From: [Murphy, Mollie](#)
To: ric7022@gmail.com
Cc: [Werner, Jeffrey B](#)
Subject: BAR # 23-05-03 - Action
Date: Wednesday, May 17, 2023 2:49:00 PM
Attachments: [image001.png](#)
[image002.png](#)

BAR # 23-05-03

485 14th Street NW, TMP 090034000

Project: Rear addition

C1
PHASE 3
April 20, 2023

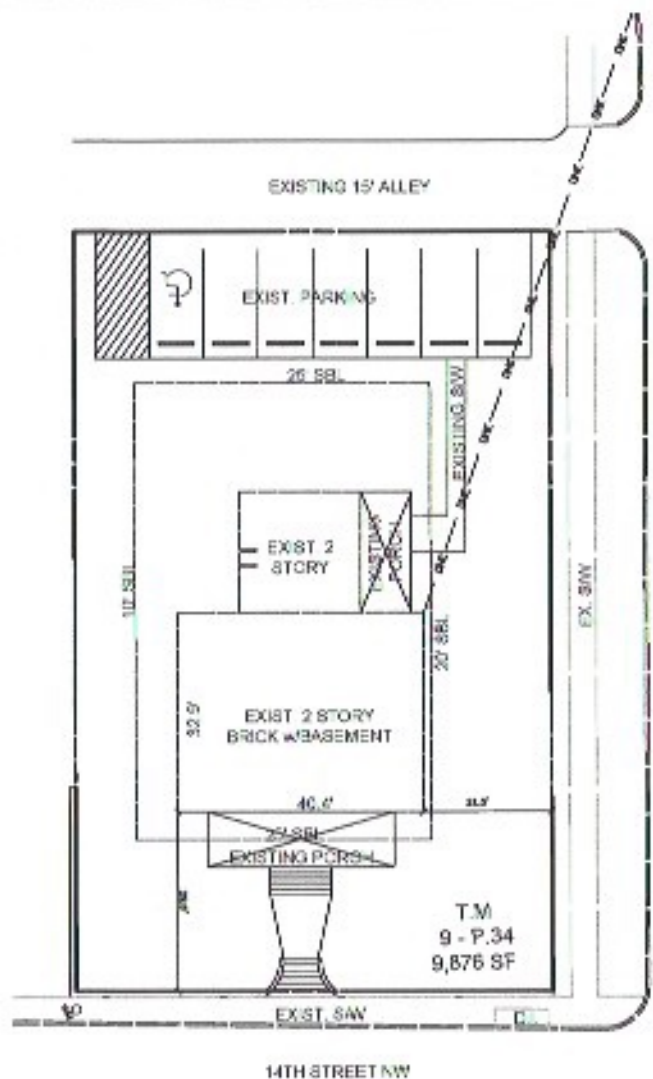
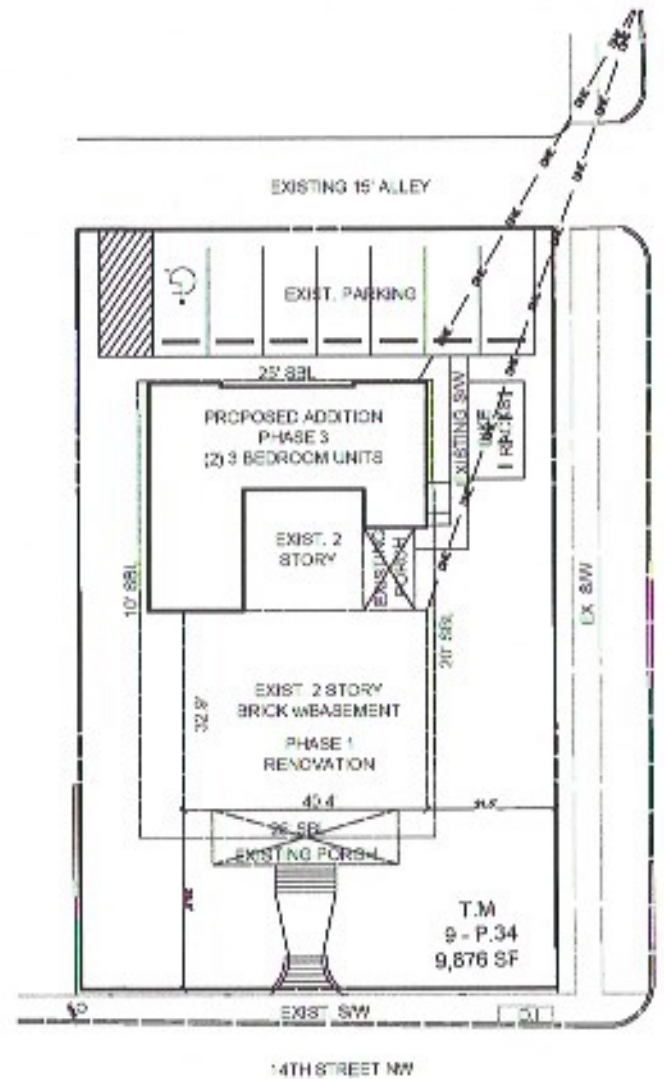
Mr. Schwarz – I am looking at your existing and proposed landscape plans. On the new plan, you have on the back corner an 18 inch black locust remain that doesn't show on the existing plan. Was that a mistake?

Mr. Gastinger – With Phase III, there are a number of plantings that are suggested in the renderings. Will we be receiving a planting plan?

Mr. Wassenaar – That tree is there and it will stay.

Mr. Wassenaar – In the phase III work, it would be demolished. It is a nice tree and one of the few trees that has any redeeming value. Unfortunately, it doesn't fit with the development plan that works in the fully developed phase. We would put in other trees to fill in that part.

Mr. Wassenaar – Yes. That’s going to be part of our site plan submission.
